IABSE Future of Design Manchester 2020

Young Designer's Competition Answers to Queries

Salford Quays Moving Footbridge

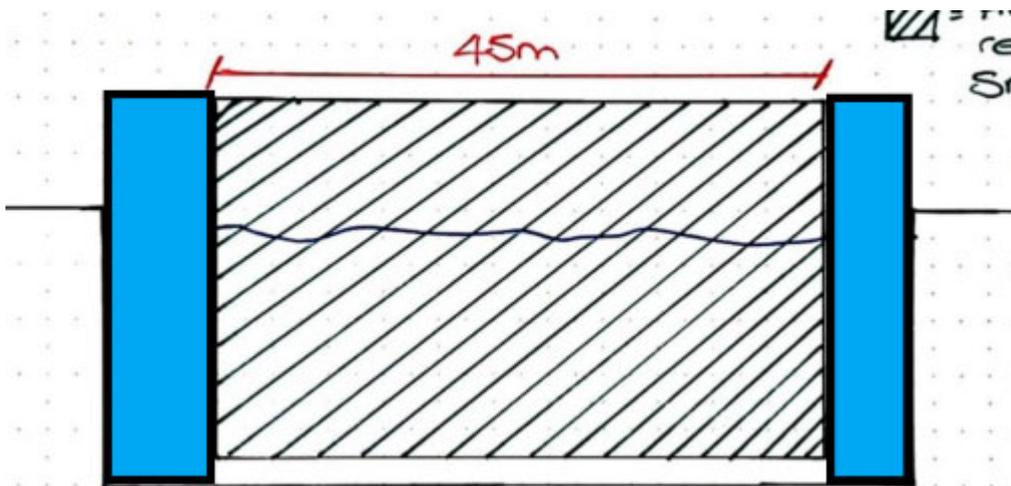
Q: There are some remnants of the old Trafford Railway swing bridge located at the proposed site (figure below). Can these be utilised for supports for our design?

- Yes, as long as assumptions are clearly stated, and consideration is given to their condition and suitability.

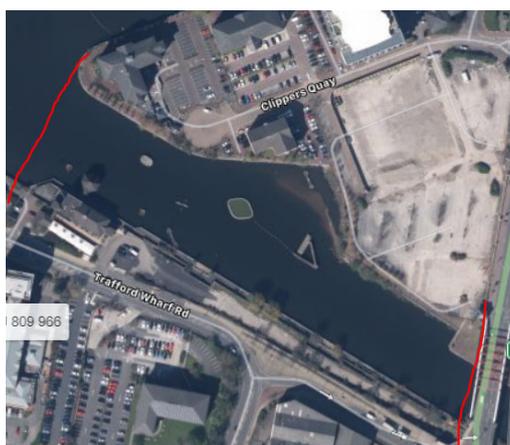
Q: How flexible is the proposed location of the bridge? Could we consider positioning the bridge 100m up or down from the location shown?

Q: Existing features at the site constrain the clear navigation width to less than the 45m requested in Figures 2 and 3 of the brief. Could the requirement be relaxed to suit this existing situation?

- The intention is that the bridge can be located anywhere between the red lines shown on the below. Justification for the proposed location should be made clear in your submission.

- The intention is that the bridge can be located anywhere between the red lines shown on the below. Justification for the proposed location should be made clear in your submission.

- The intention is that the bridge can be located anywhere between the red lines shown on the below, but a 45m clear navigation width must be achieved. Justification for the proposed location should be made clear in your submission.
